Meeting of the Mashpee Planning Board

Location: 523 Main Street (Map 26, Block 6)

Request: The applicant requests consideration for approval of a 9 lot definitive subdivision plan of land consisting of approximately 18.05 acres located on Main Street (Route 130) between Nicoletta's Way and Echo Road

DEFINITIVE SUBDIVISION PLAN

PLAN & PROFILE LEAMAR DRIVE

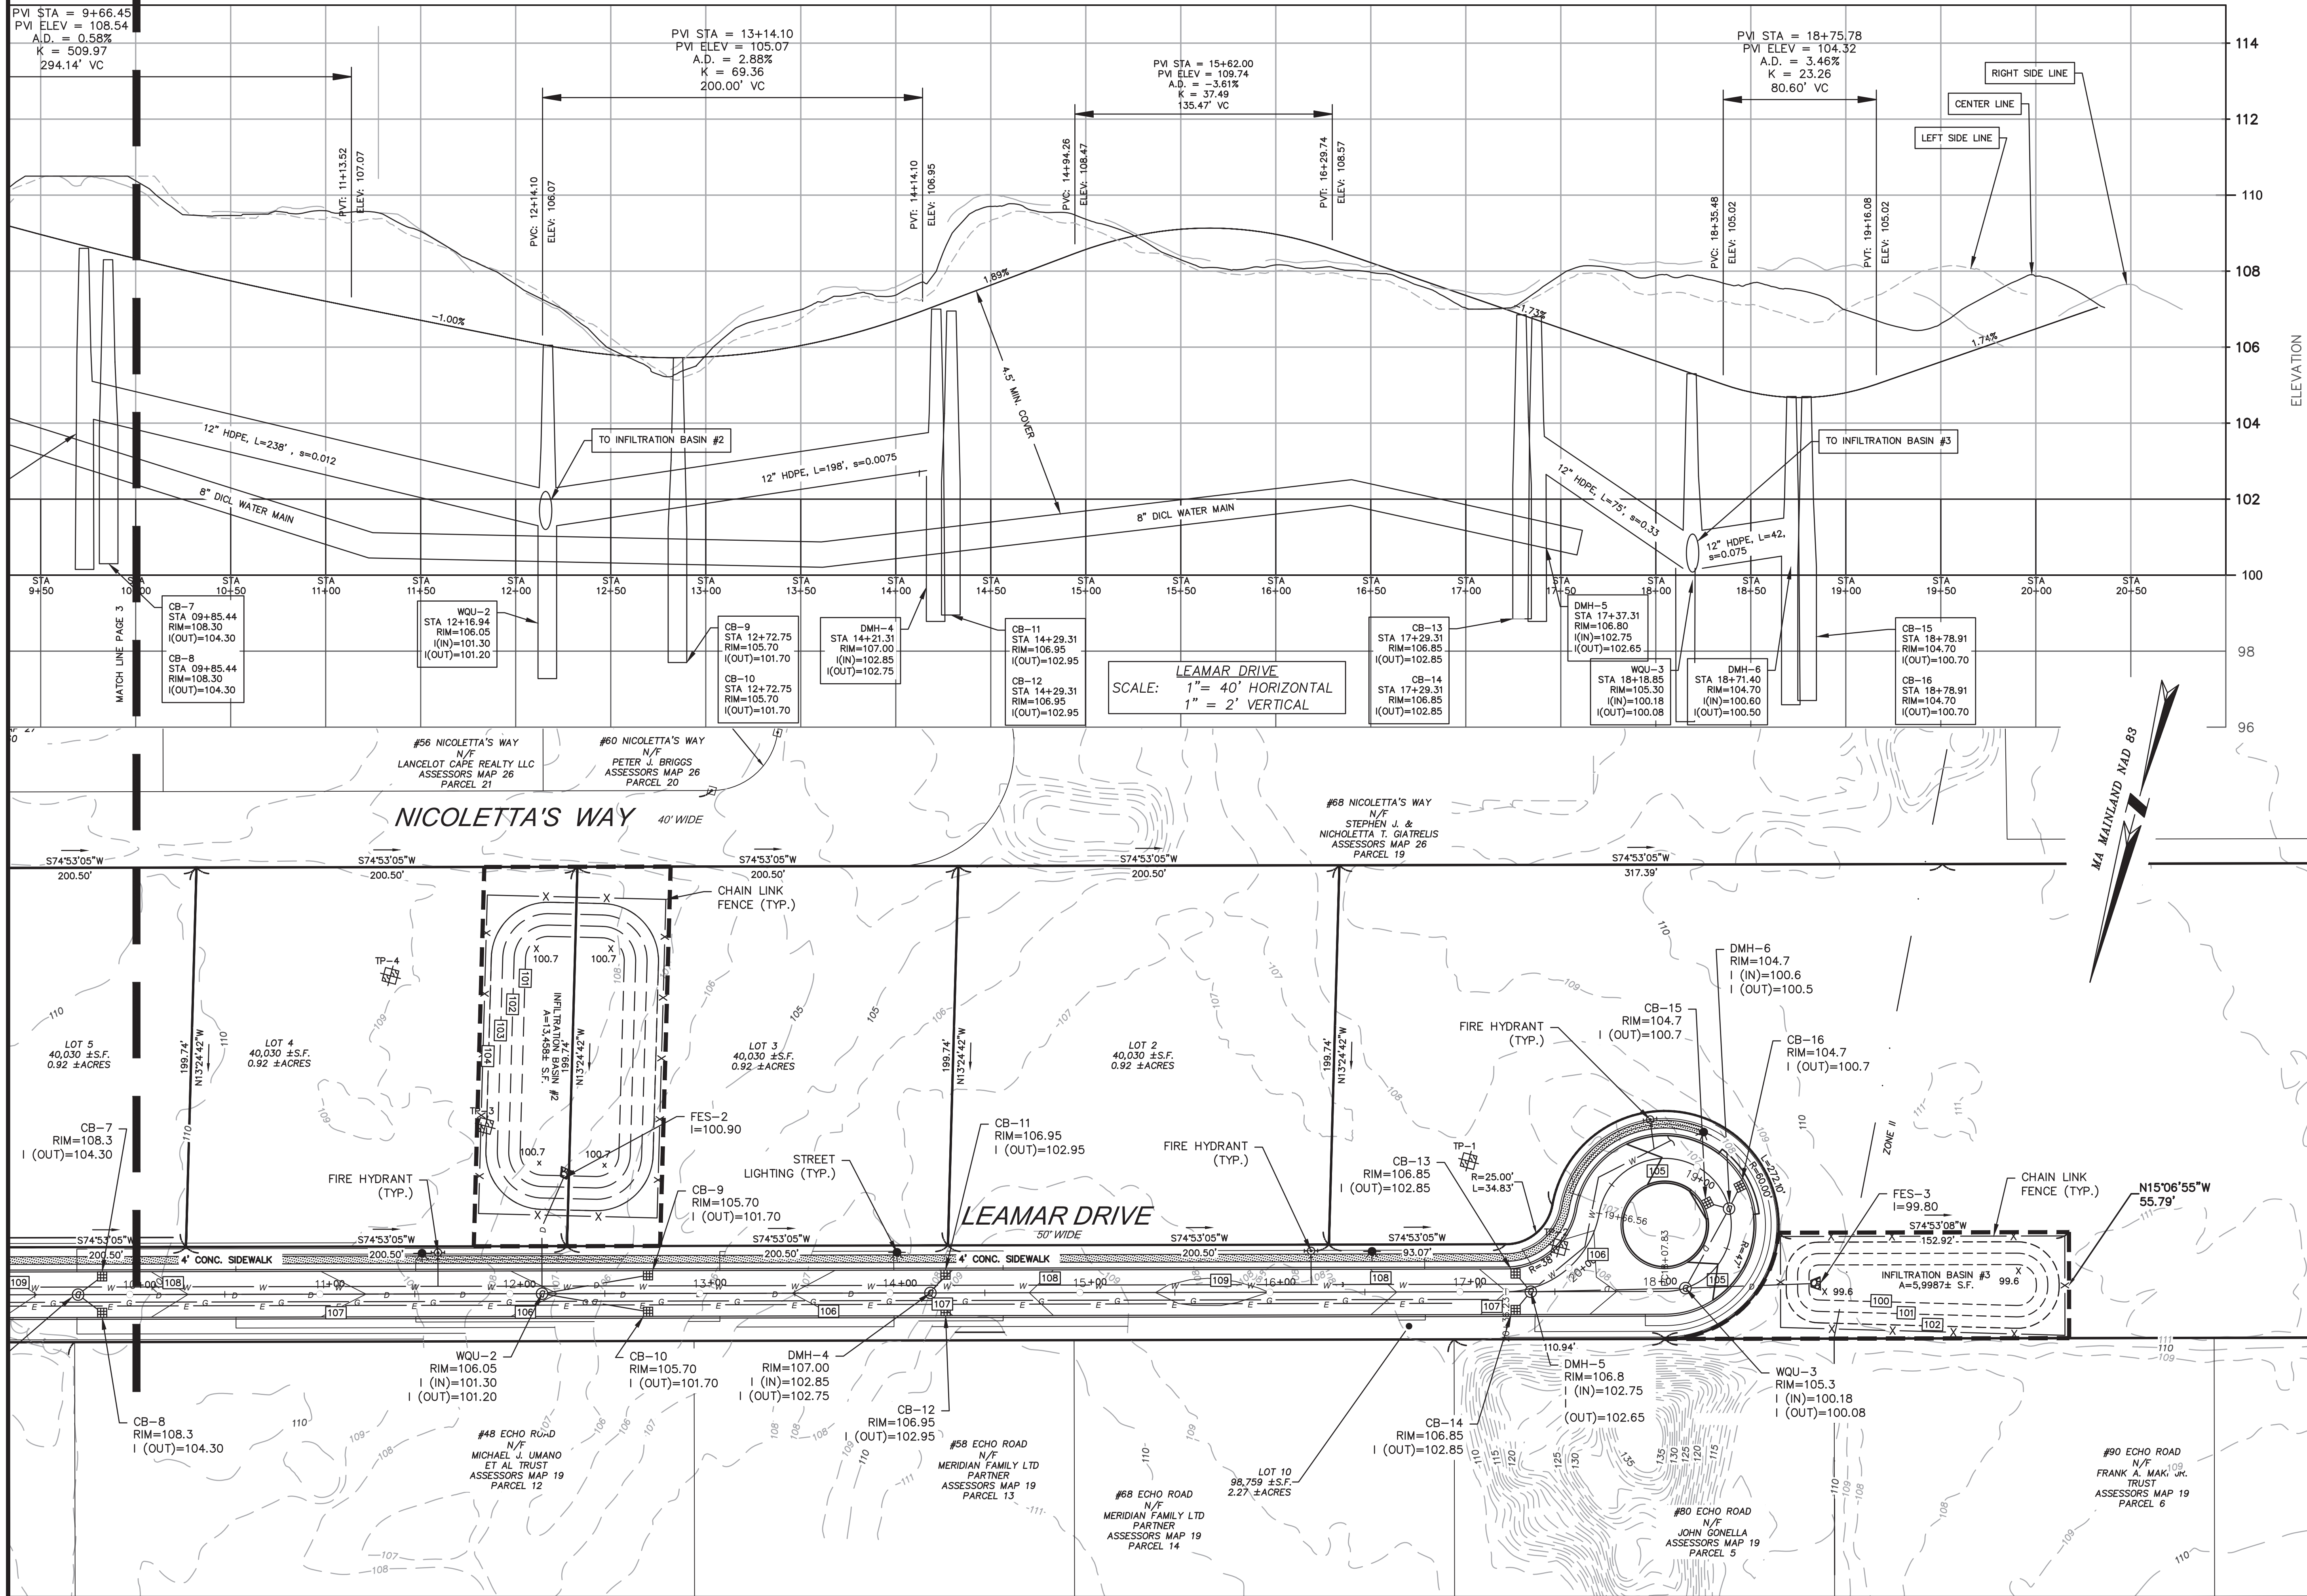
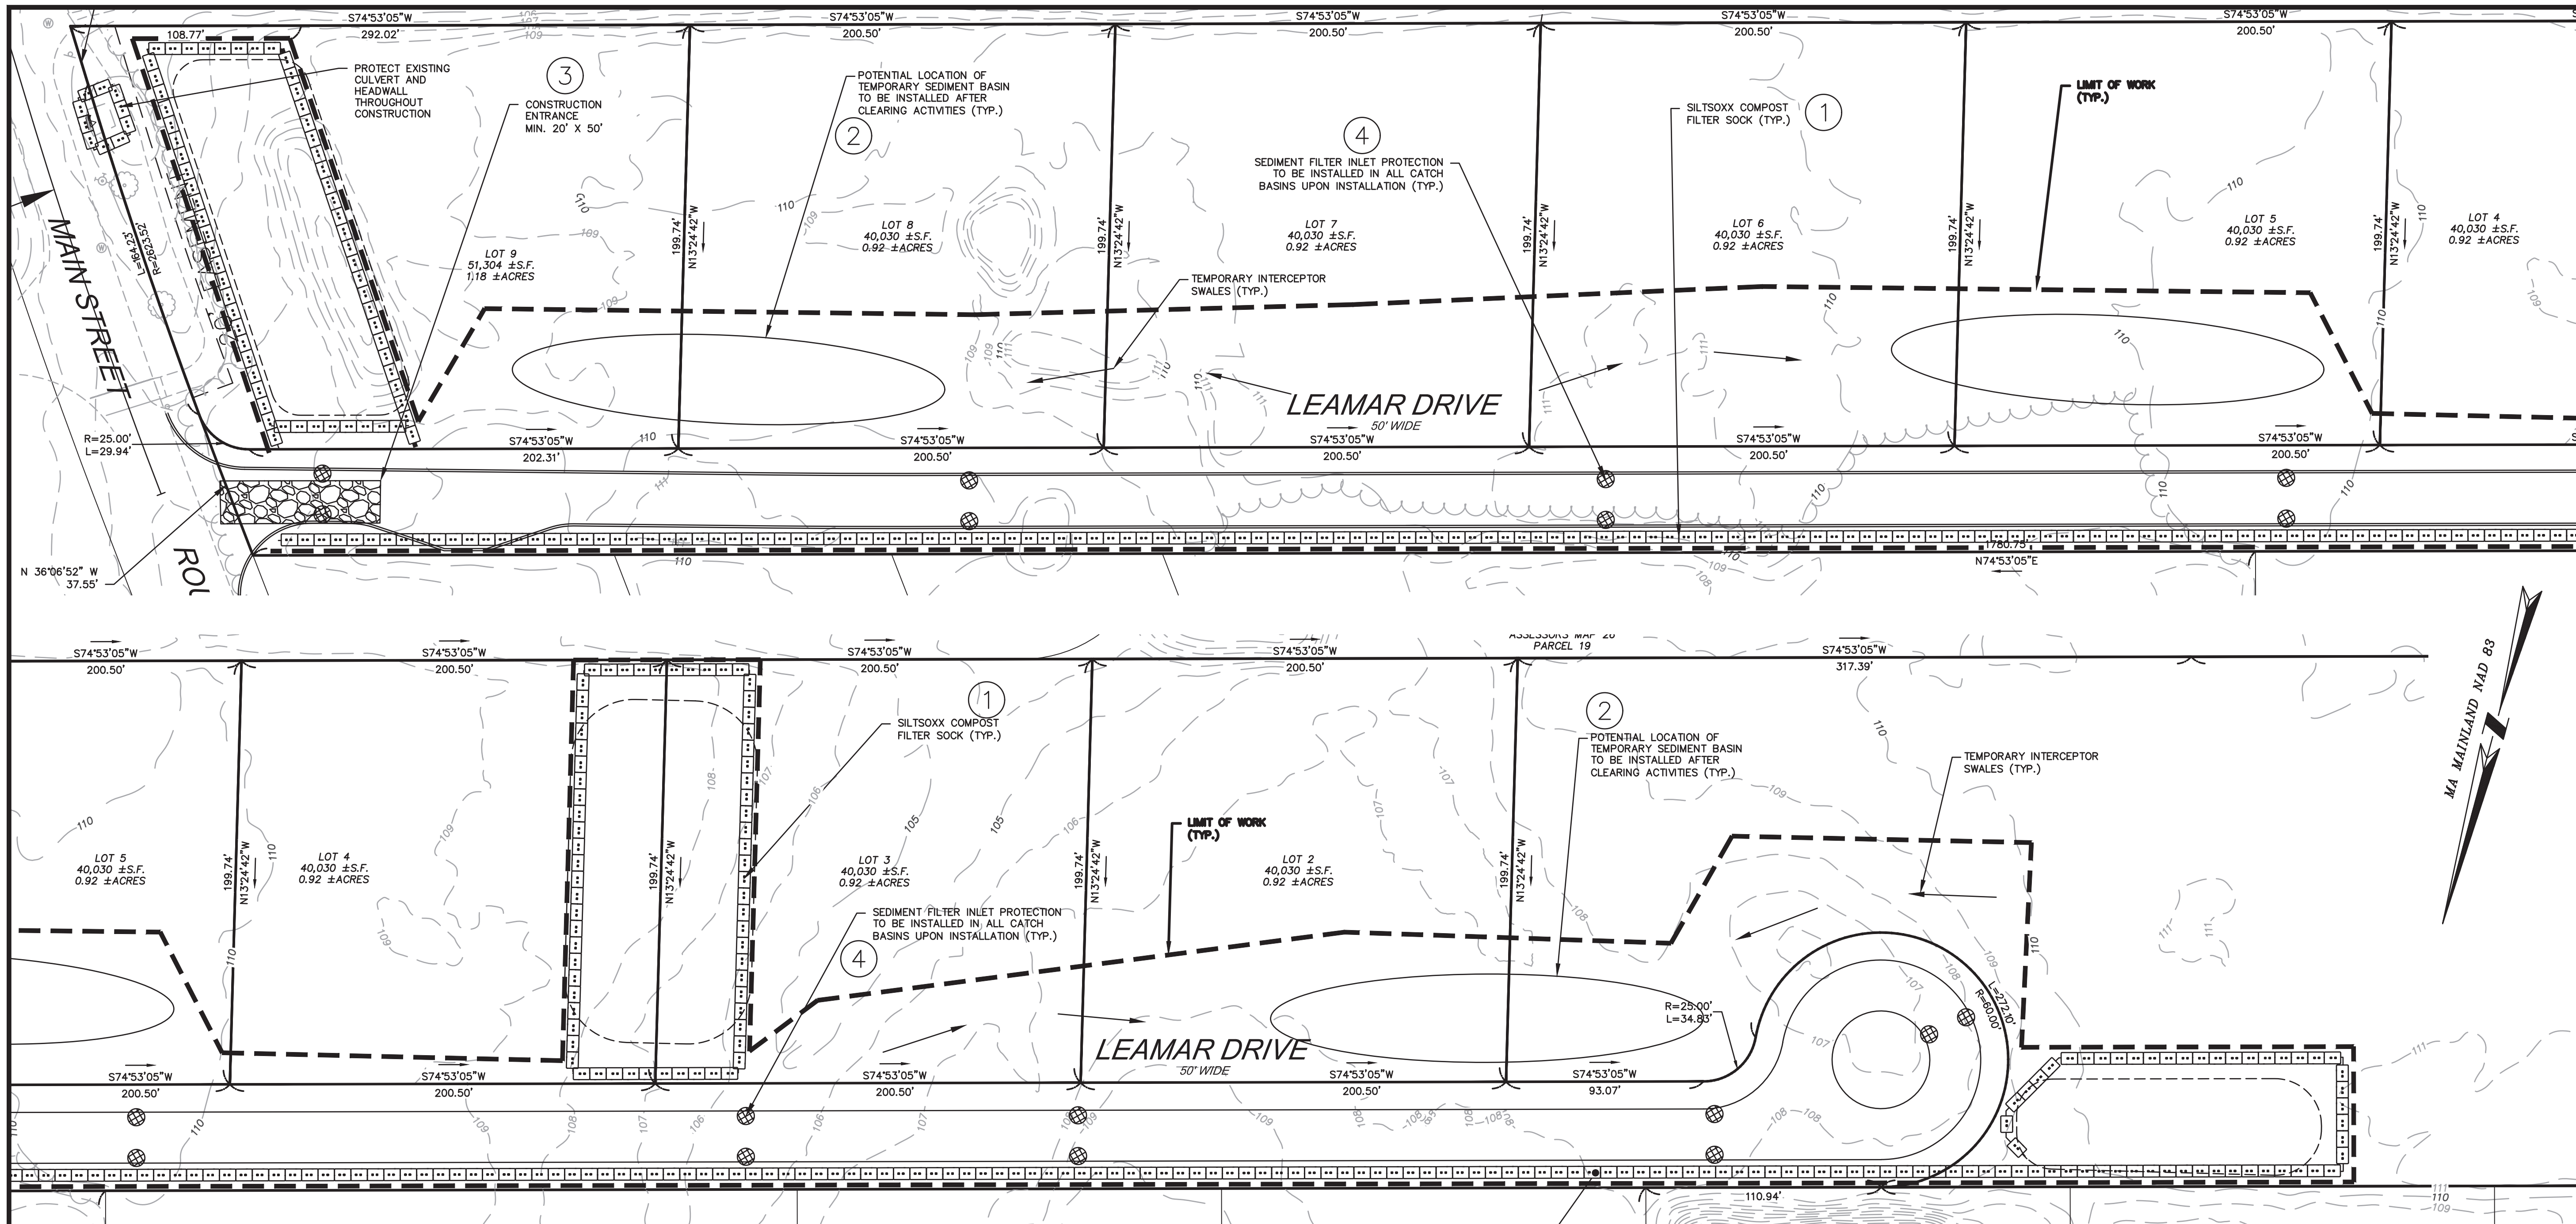
2. The proposed contours for the infiltration basins on the plans need to be labeled for clarity during construction.
3. There is an existing culvert and concrete headwall for a drainage pipe crossing Rt. 130 at the northern end of the site. We recommend that the Erosion & Sediment Control Plan (sheet 5 of 8) show appropriate erosion controls at this inlet for the construction period.
